PIC16CR63

PIC16CR63 Rev. A Silicon Errata Sheet

The PIC16CR63 parts you have received conform functionally to the Device Data Sheet (**DS30234D**), except for the anomalies described below.

FIGURE 1: WRITES TO TIMER1 (EXTERNAL CLOCK / OSCILLATOR MODE)

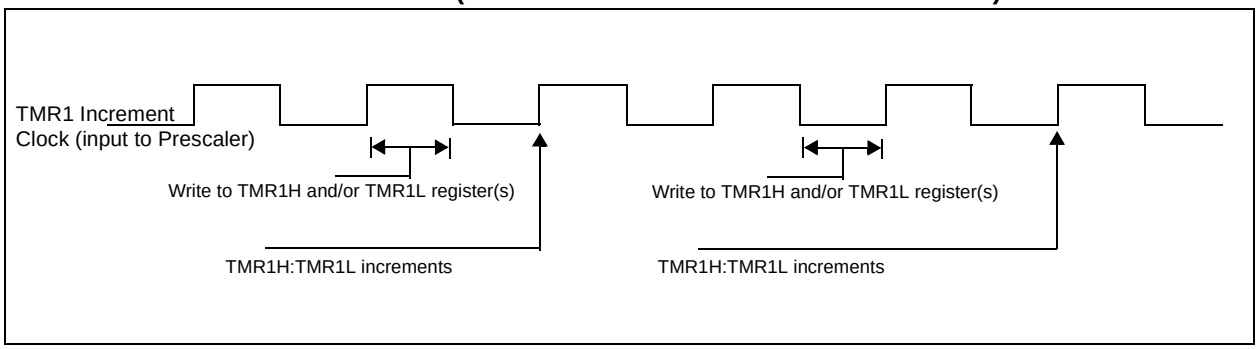
a) The operation of Timer1 needs some clarification when the timer registers are written when the TMR1ON bit is set.

The internal clock signal that is the input to the TMR1 prescaler affects the incrementing of Timer1 (TMR1H:TMR1L registers and the Timer1 prescaler). When the Timer1 registers are NOT written, the Timer1 will increment on the rising edge of the TMR1 increment clock.

When the TMR1H and/or TMR1L registers are written while this clock is high, TMR1 will increment on the next rising edge of this clock.

When the TMR1H and/or TMR1L registers are written while this clock is low, TMR1 will not increment on the next rising edge of this clock, but must first have a falling clock and the the rising clock for TMR1 to increment.

Figure 1 shows the two cases of writes to the TMR1H and/or TMR1L registers. Due to the VIH and VIL thresholds on the oscillator/clock pins, external Timer1 oscillator components, and external clock frequency, the Timer1 increment clock may not be of a 50% duty cycle.

The TMR1 increment clock is out of phase of the T1OSO/T1CKI pin by a small propagation delay.
